UNITED STATES PATENT AND TRADEMARK OFFICE

APPLICATION NO.	FILING DATE	FIRST NAMED INVENTOR	ATTORNEY DOCKET NO.	CONFIRMATION NO.
10/533,990	05/04/2005	Andreas Wunderlich	040085.00004	2585

Office Action Summary	Application No. 10/533,990	Applicant(s) WUNDERLICH, ANDREAS	
	Examiner Katherine W. Mitchell	Art Unit 3677

DETAILED ACTION

EP 0 501 860 A1

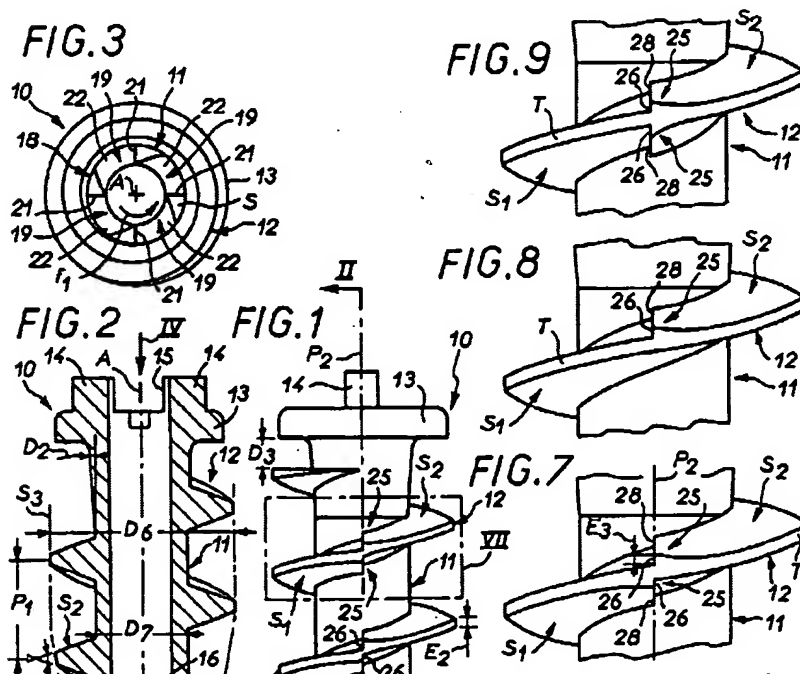
7. As best understood, claims 1,4,5, 7, 9, and 11-14 are rejected under 35 U.S.C. 102(b) as being anticipated by Auger EP 0501860.

Auger teaches in the Figures and abstract a screw capable for use on hard materials, with a shaft, head at one end, tip, and a thread with cutting teeth on a thread side facing away from the head that are alternately inclined to the left and right of a centerline. The thread flattened crest forming a narrow face (T) with edges 28 extending across it. The edges on at least one side are roughly radially disposed and extend all the way down to the shaft (Fig 10, copied below, and Fig 6, not copied, best shows this). The included angle between sides S1 and S2 of the thread are in a range of 20-30 degrees at the portion due to penetrate the drilled hole wall. The included angle between sides S1 and S2 of the thread are in a range of 45 to 60 degrees over the transition zone immediately adjoining the shaft. Fig 7 and 8 show the teeth (on upper vs lower sides) offset from one another by the width of their face. The set of teeth vary over the shaft length- some are on one side, some are on the other, which is varied.

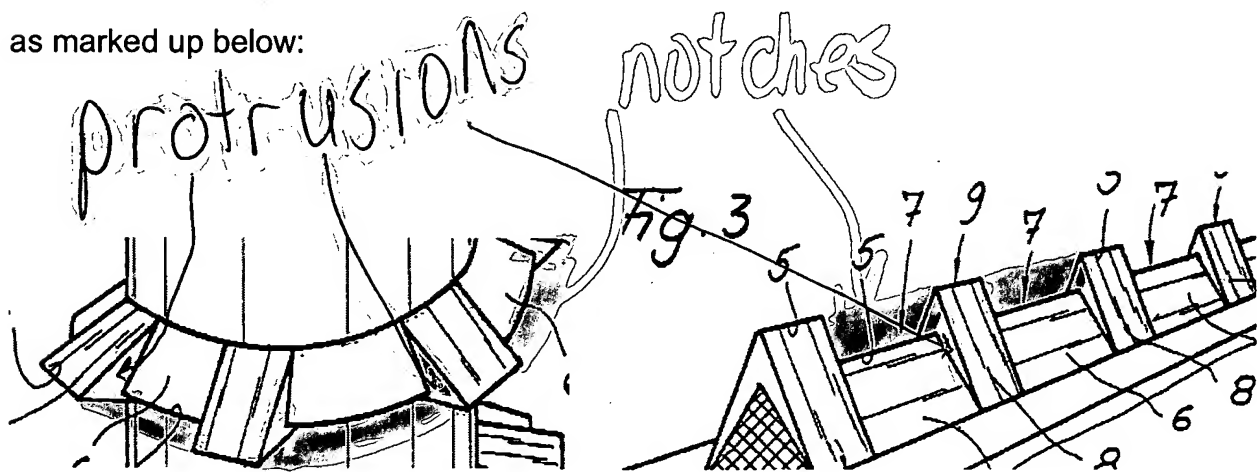
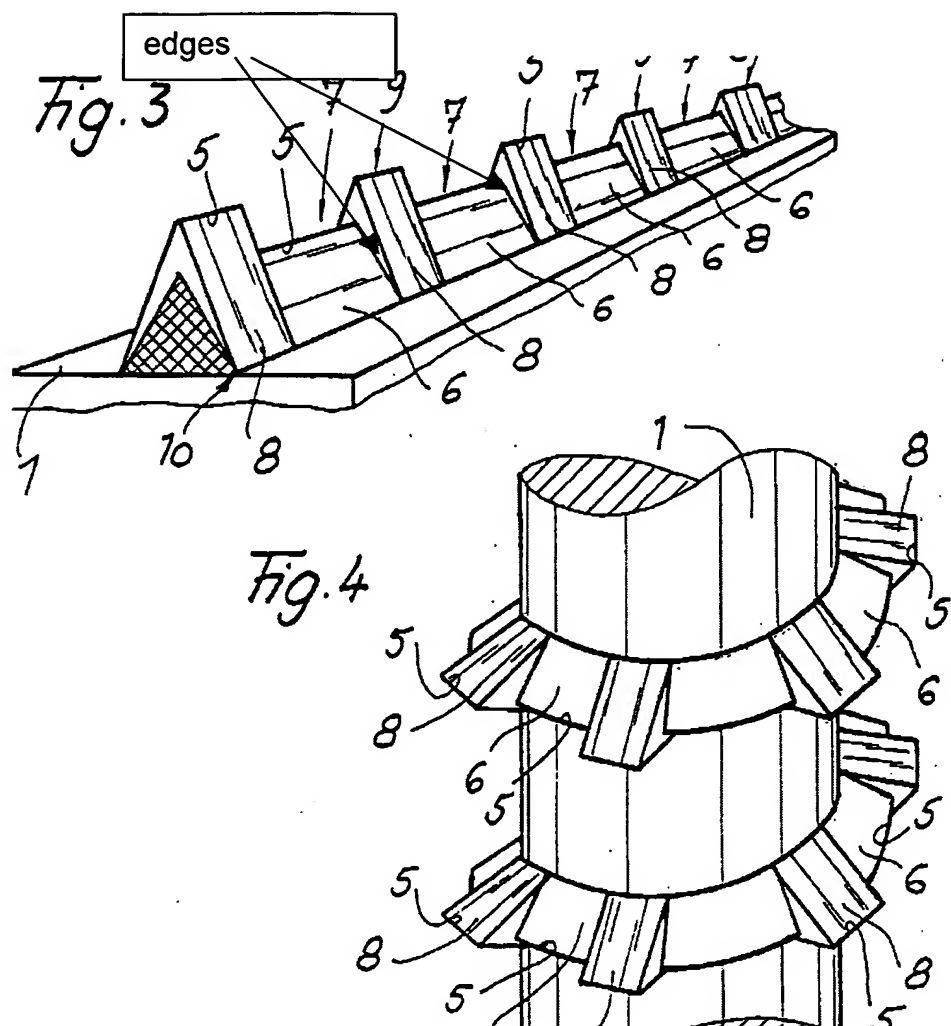
8. As best understood, claims 1-3 and 5-12 are rejected under 35 U.S.C. 102(b) as being anticipated by Munz DE 4206440.

Munz teaches in the Figures and abstract a screw capable for use on hard materials, with a shaft, head at one end, tip, and a thread with cutting teeth on a thread side facing away from the head that are alternately inclined to the left and right of a centerline. The thread has a sawtooth profile with the leading edges of the sawteeth roughly radially disposed wrt the screw longitudinal axis (Fig 4). The thread crest has edges extending across it. The edges on at least one side are roughly radially disposed and extend all the way down to the shaft (Fig 4). The thread has a row of laterally offset teeth bordering on one another (fig 4). Note that the notches of a side are considered the "missing" material that would fill in past the outer edge 5 of main thread to be flush with the outer edges of sawteeth at "5"; the protrusions are the 'height' of the sawteeth as marked up below:

The notches do not extend all the way to the shaft. The included angle between sides S1 and S2 of the thread are in a range of around 20-30 degrees at the portion due to penetrate the drilled hole wall. The included angle between sides S1 and S2 of the

thread are in a range of around 45 to 60 degrees over the transition zone immediately adjoining the shaft.
